Submission ID: 217819

Objection to SSD-9409987: Moss Vale Plastics Recycling Facility

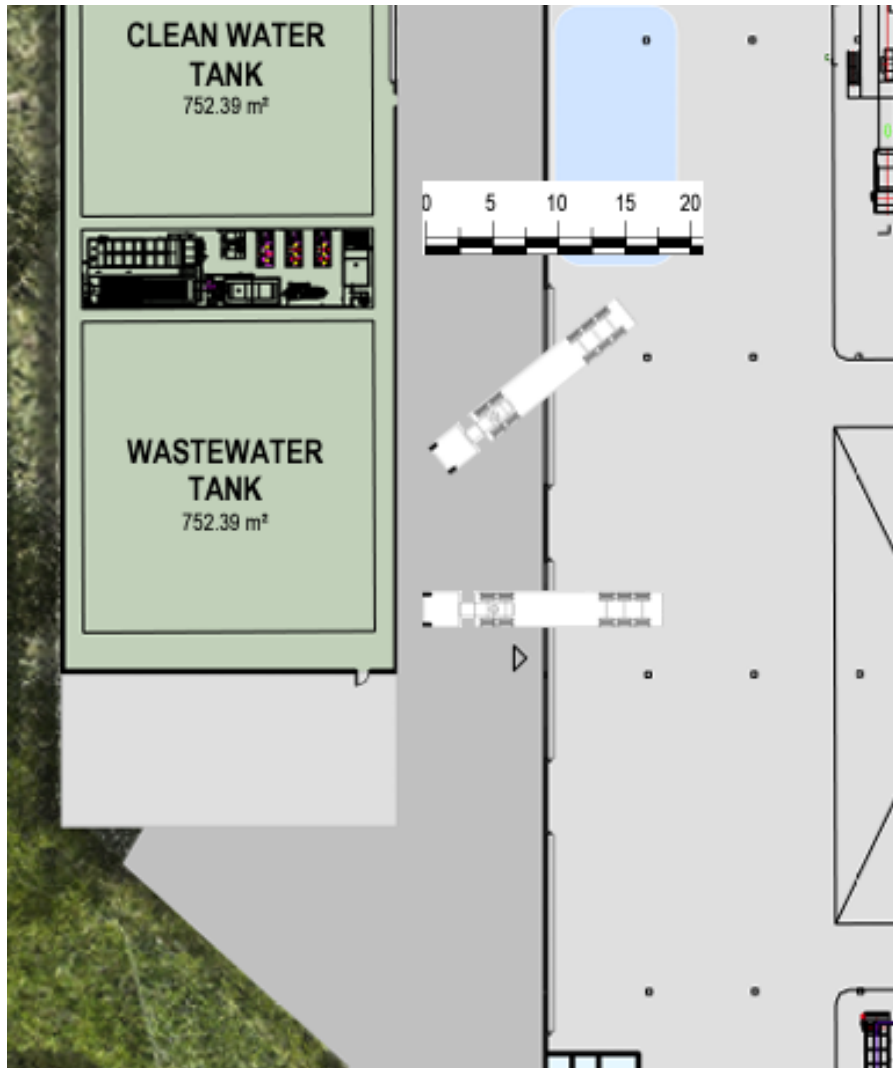
Moreover, the April 2024 architectural plans show three roller doors in close proximity (see IMAGE 15 below), suggesting that multiple trucks might be expected to unload simultaneously. This raises questions about whether a proper swept path analysis has been conducted by a qualified traffic engineer. Without such analysis, there is a high likelihood of traffic congestion, delays, and further extended door-opening periods.

Another critical issue, especially in light of the inevitable relocation of the water tank structure to allow for truck turning circles, is the effectiveness of the facility's negative air pressure system. GHD claims this system will prevent microplastics from escaping during door operation - David Gamble on Day 3 of IPC talks said that no air would blow into the westerly garage doors because there is no 'open window' outlet for the winds. This assertion is dubious, especially during strong westerly gusts that regularly exceed the doors' wind tolerance. Especially without the Wastewater Tank structure to shield them. Negative air pressure systems are essentially large suction fans, which act as open outlets for air. During high westerly wind events, the airflow into the building could overwhelm these fans, compromising their effectiveness.
